## Port Credit Heritage Conservation District Subcommittee

# City of Mississauga

Meeting date: May 3, 2021

Subject: **Request to Alter 24 John Street South (Ward 1)**

Appendix 1: Proposed Garage Design

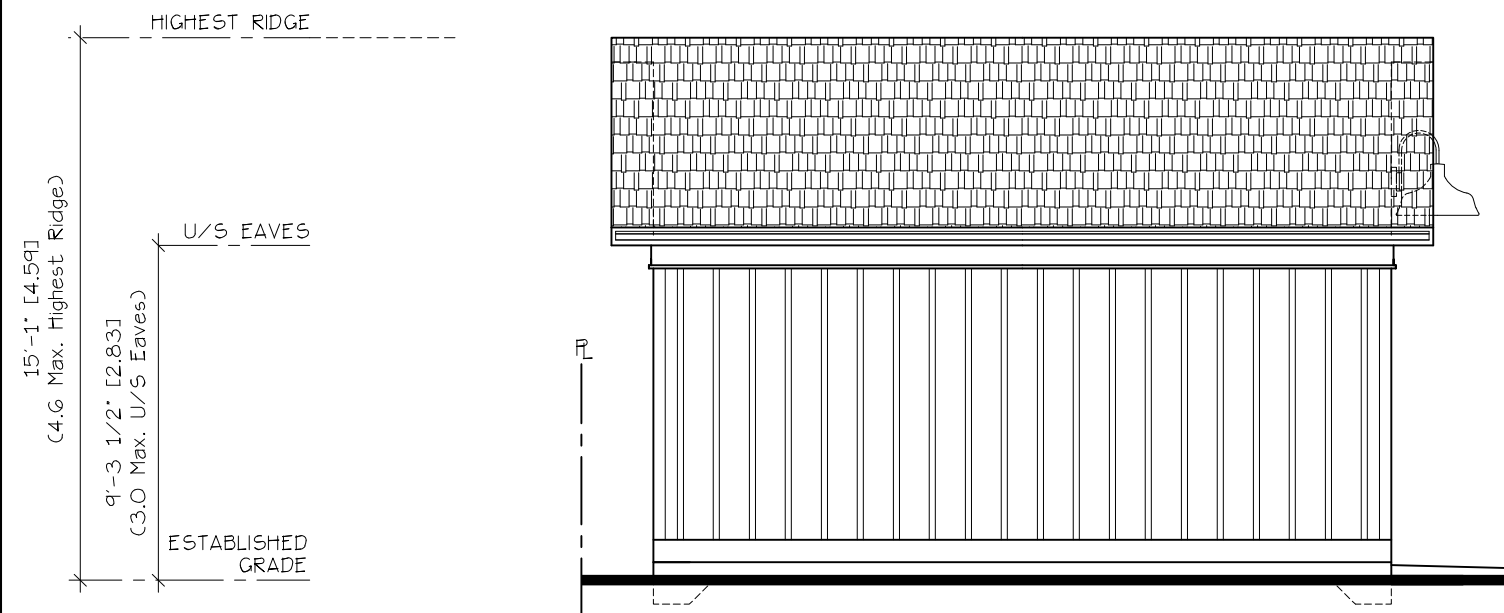
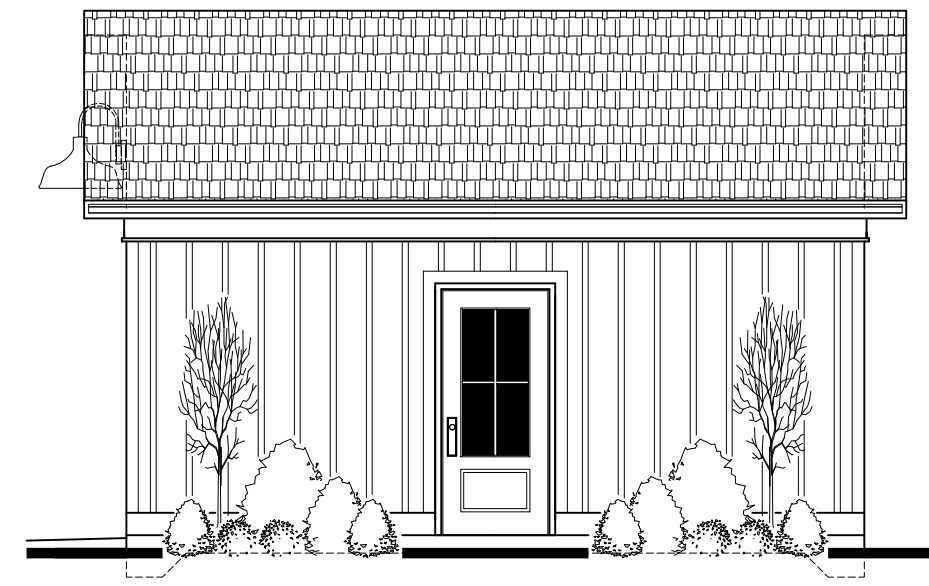
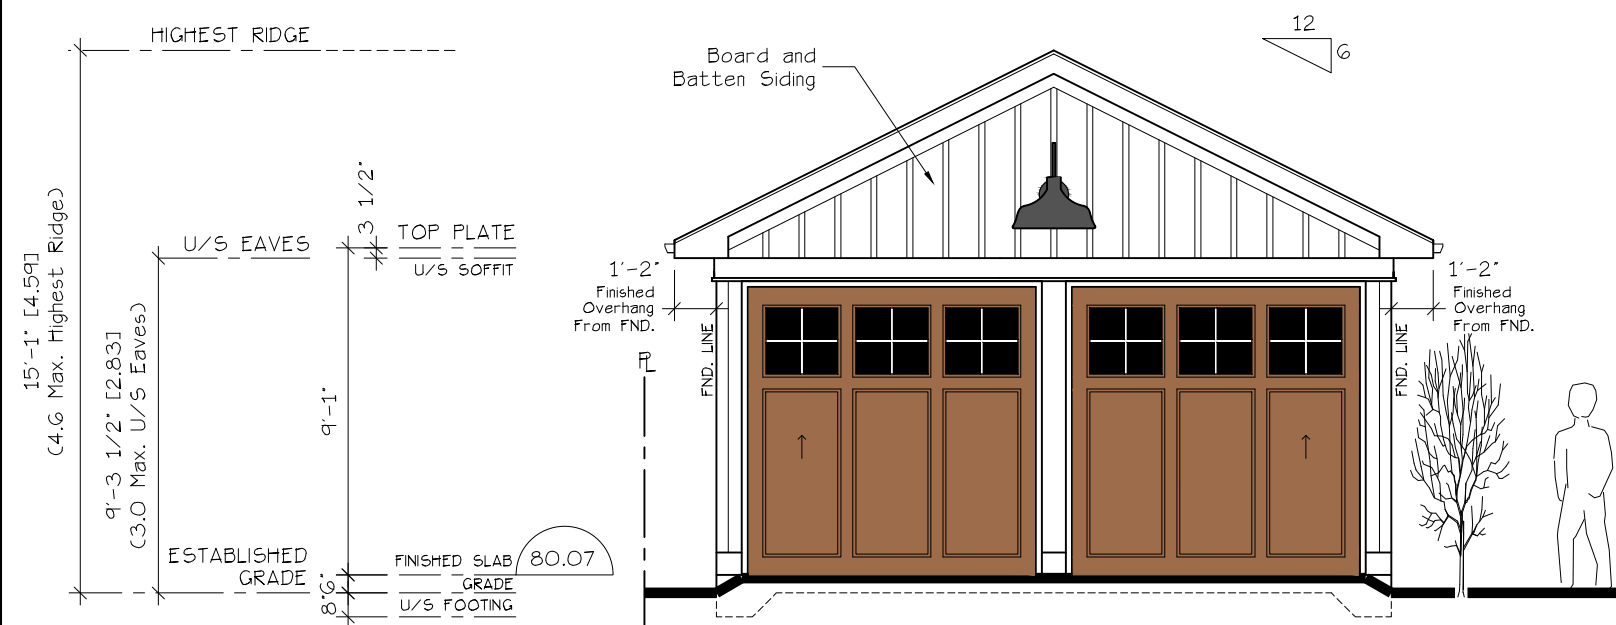
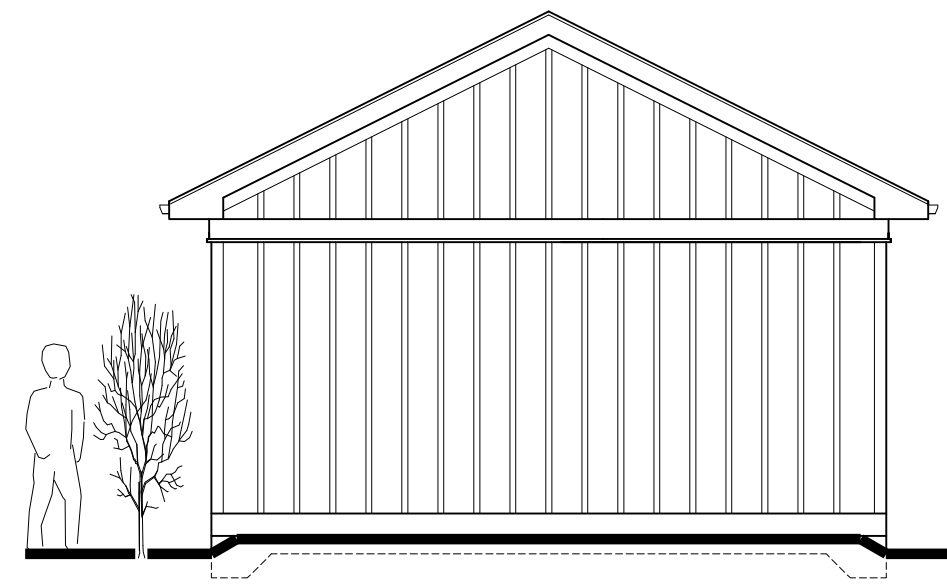
The City permitted a new dwelling and detached single car garage at the subject property earlier this year (See item 8.2 here). The owner now proposes a wider two-car two-door garage. The proposal is attached as Appendix 1. The revised proposal would require a variance as it would increase the gross floor area (GFA) to 35.75m<sup>2</sup> from the allowed 30m<sup>2</sup>. The increased area is at the rear of the property. No other variances have been required for this proposal. The garage is simple and complementary and is similar to other approved two car garages on new builds within the HCD. For these reasons, Heritage Planning recommends approval subject to Committee of Adjustment approval.

That the request to erect a two car garage at 24 John Street South, as per the memorandum from John Dunlop, Manager of Heritage Planning & Indigenous Relations, dated April 16, 2021, be approved.

**EXTERIOR RAMP AND STAIR PLAN**  
SCALE: 1/4"=1'-0"

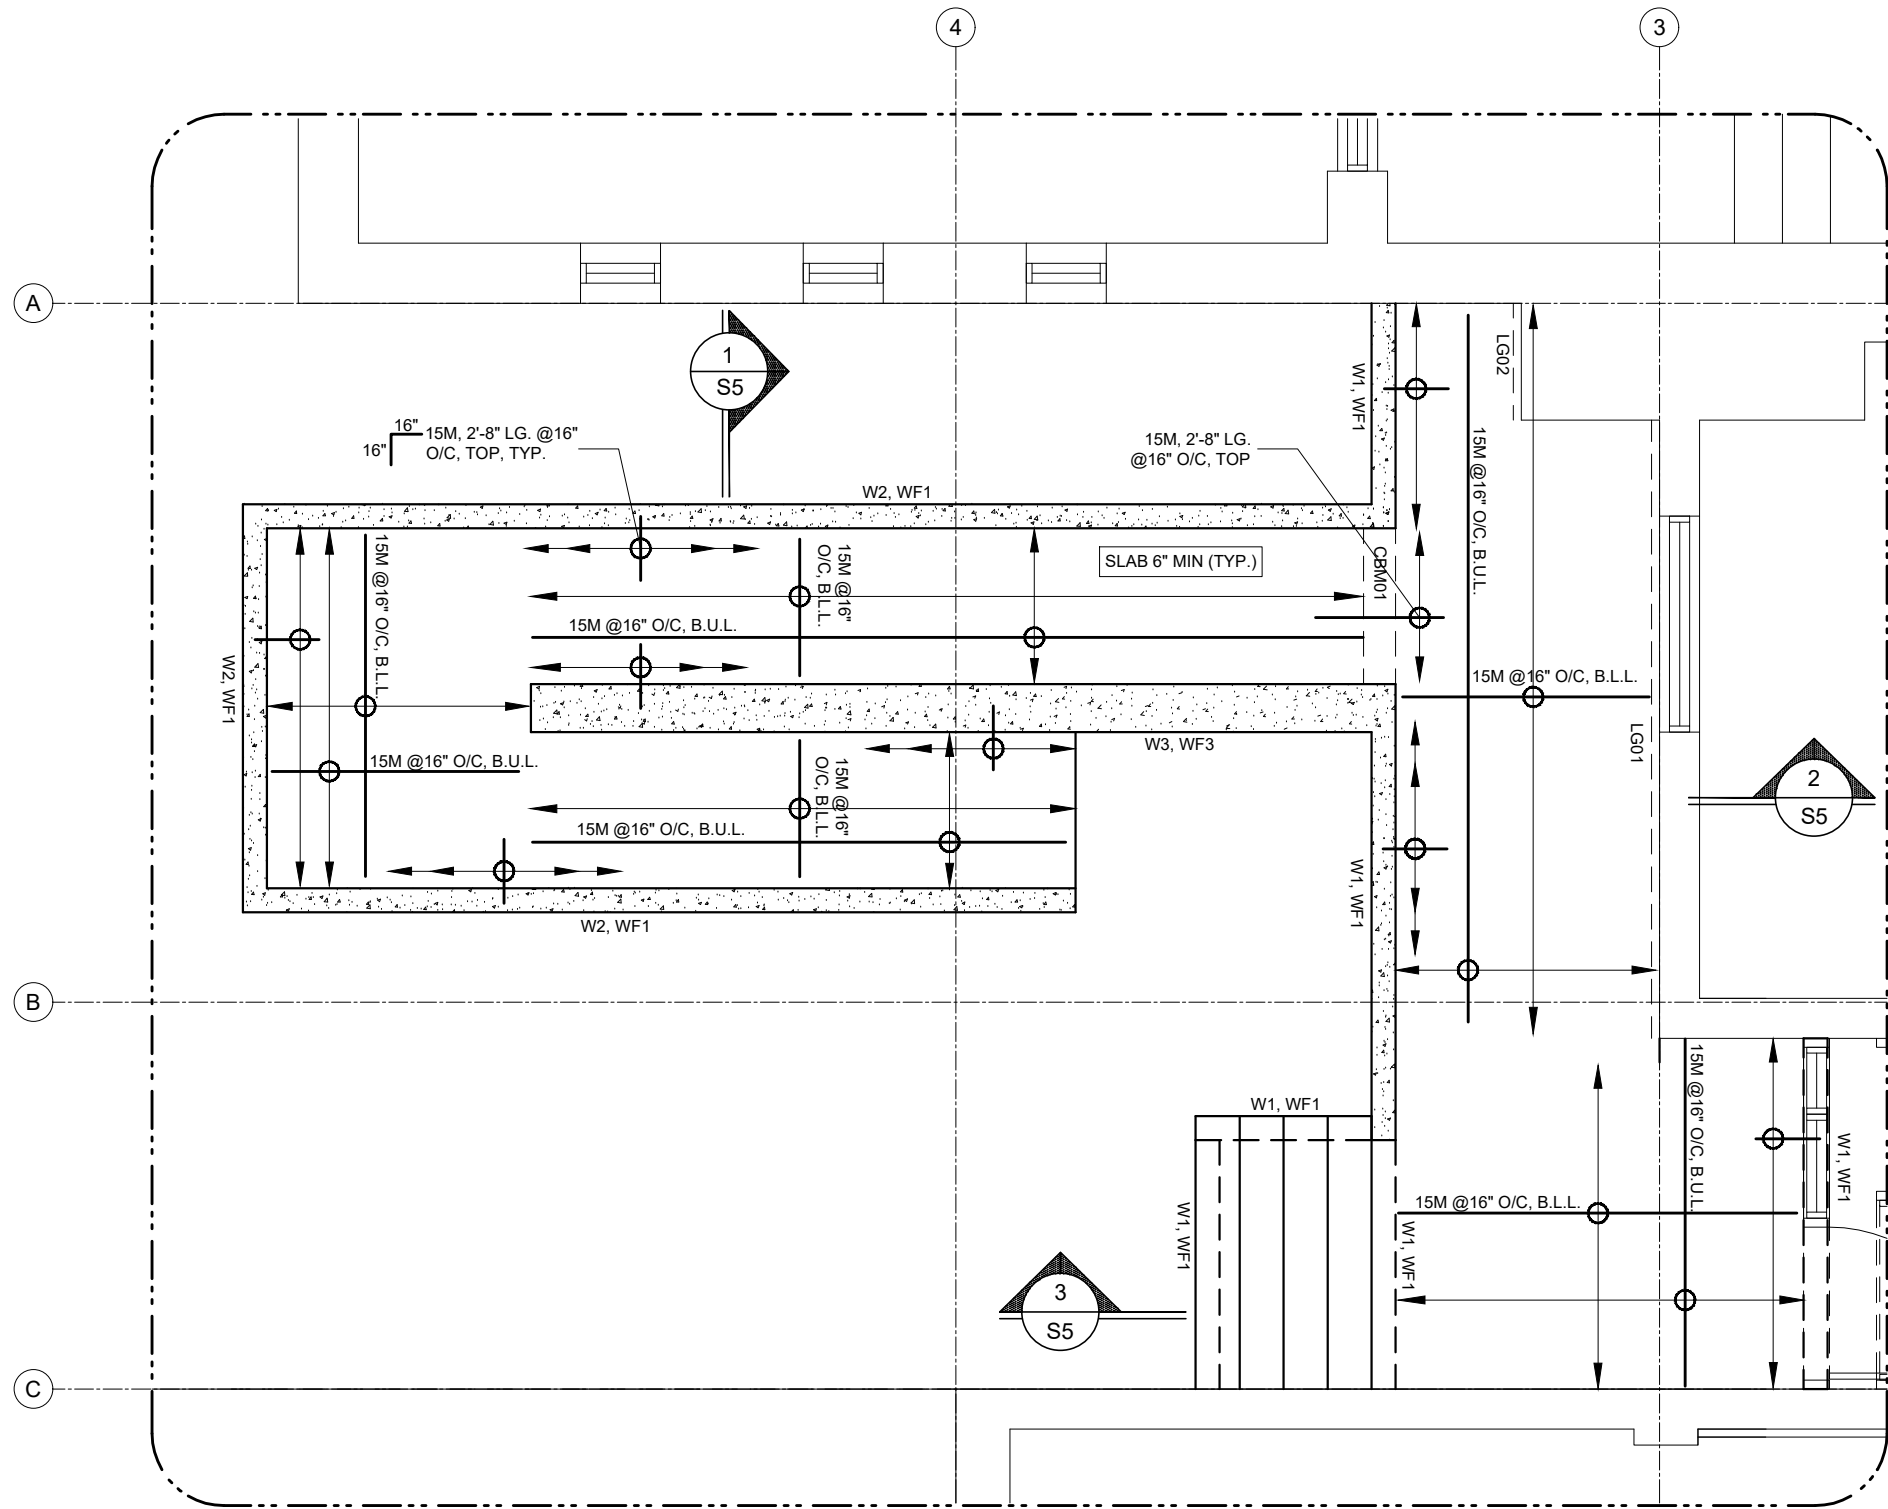
The proposed ramp is a simple “predominantly freestanding concrete structure” that would replace the existing landing. It includes a metal railing and glass guard. The stairs and path are also proposed to be replaced but would reuse the existing flagstone. The HCD Plan states that ramps: “should not be physically attached in order to avoid damage to the heritage building fabric. In some circumstances, attachments may be permitted where they cause the least amount of damage to heritage building fabric” (13.1.3). The ramp would be anchored into the building; however, the impact is minimal and necessary to provide barrier-free access.

That the request to install a ramp and replace doors and windows at 11 Peter Street South, as per the memorandum from John Dunlop, Manager of Heritage Planning & Indigenous Relations, dated April 16, 2021, be approved.

1 DOOR AND WINDOW TYPES

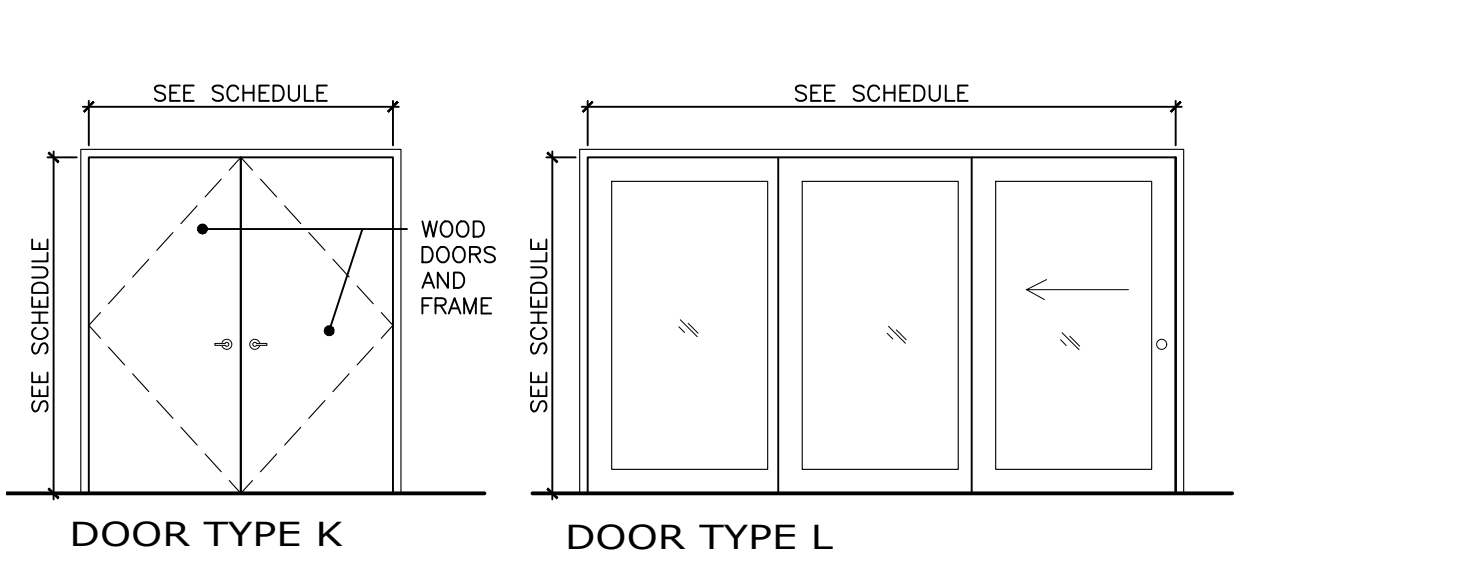
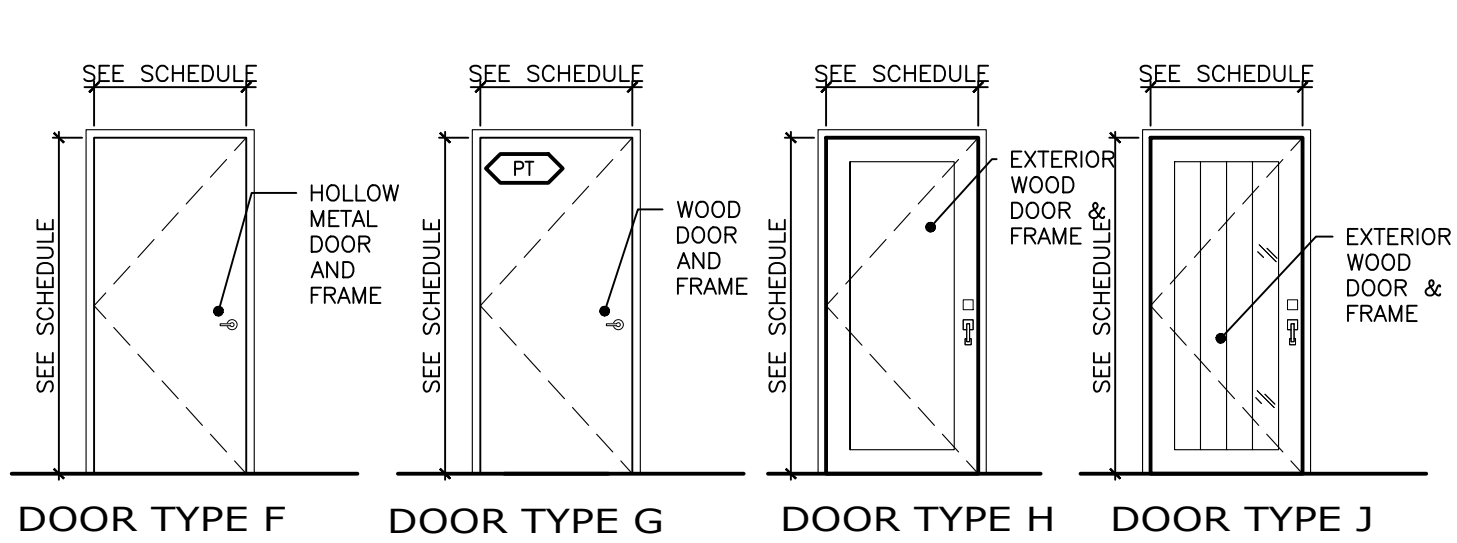
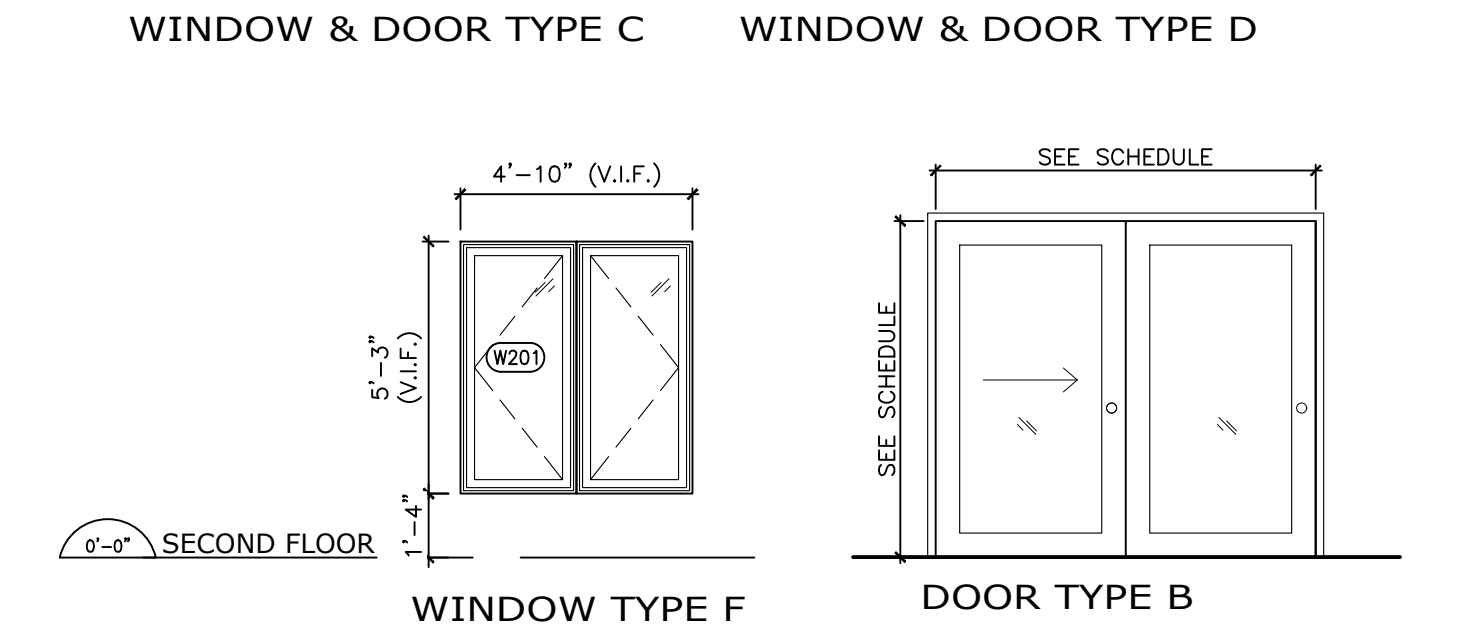
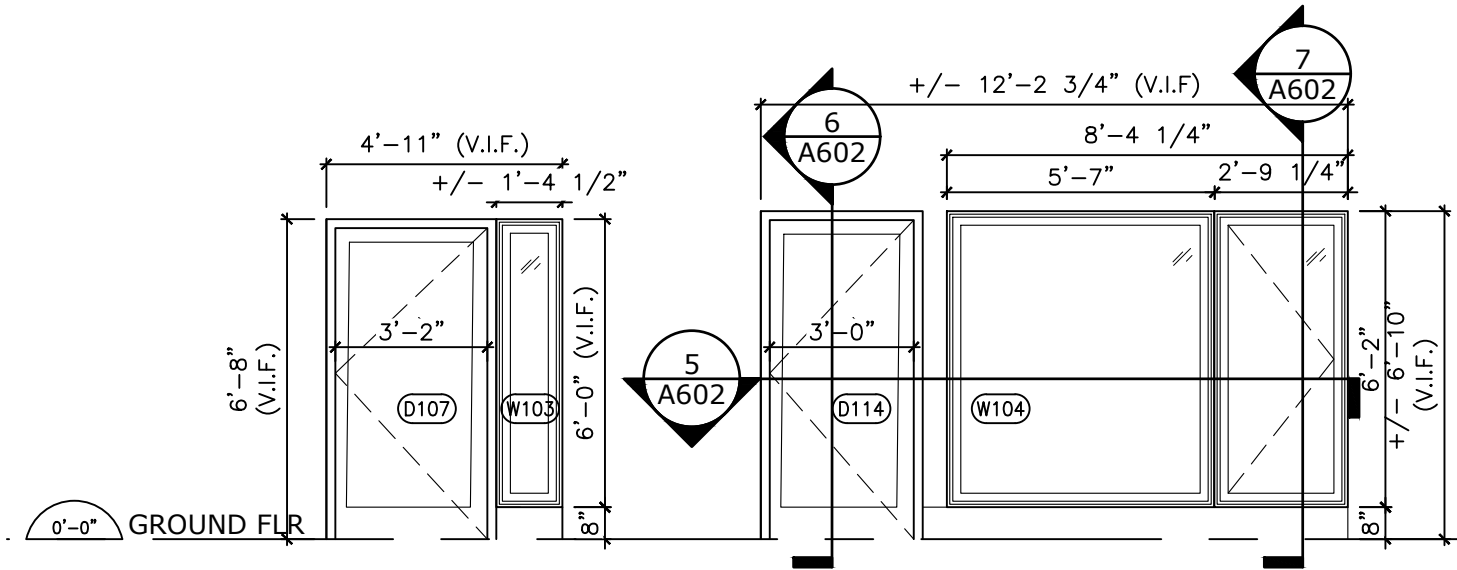
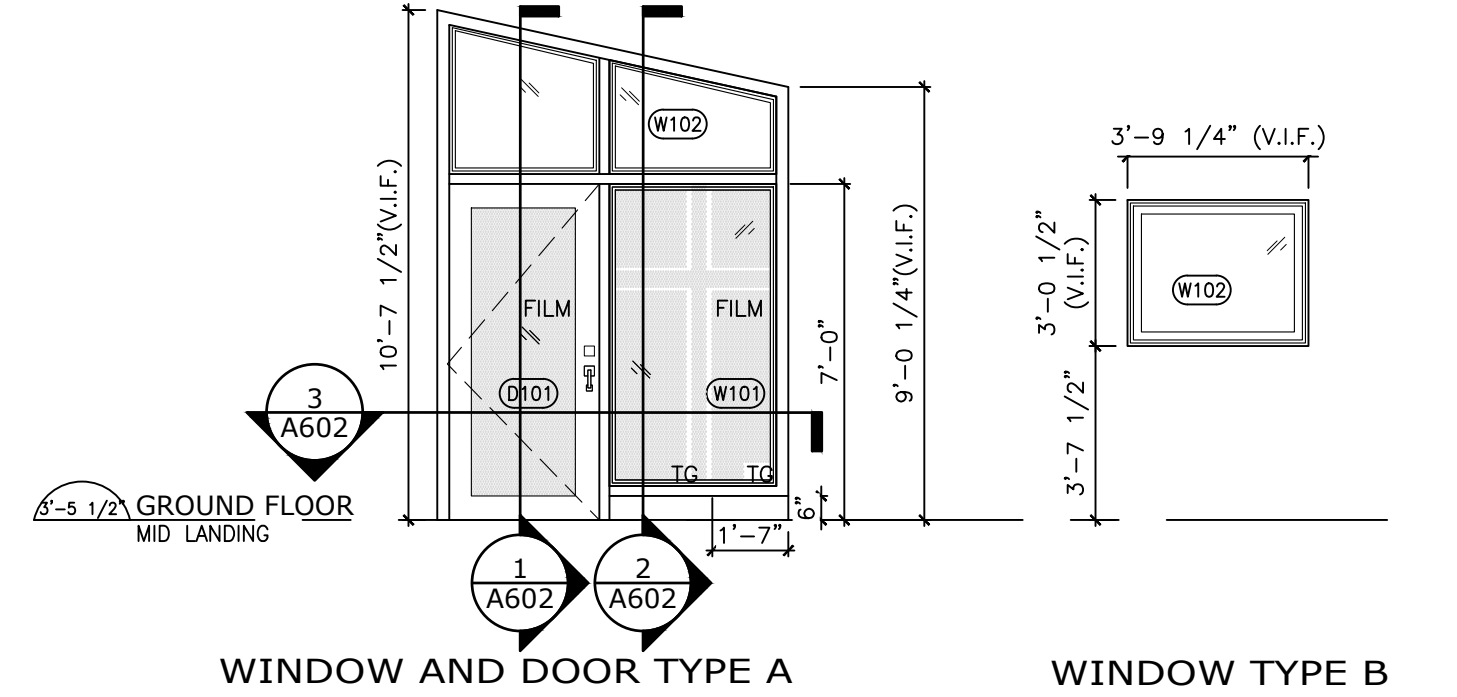
On the rest of the building, several doors are proposed to be replaced. (See drawings.) Door type "C" would replace the sliding glass doors at the mechanical courtyard to provide more security. A door would replace the ground floor window to the south of the main entrance (also on the west face) as this area forms a separate unit. This area is currently and would remain shielded from view by a fence. A new wood balcony is proposed on the south face with tempered glass panels. All of these doors either match what is existing or are similar and simple.
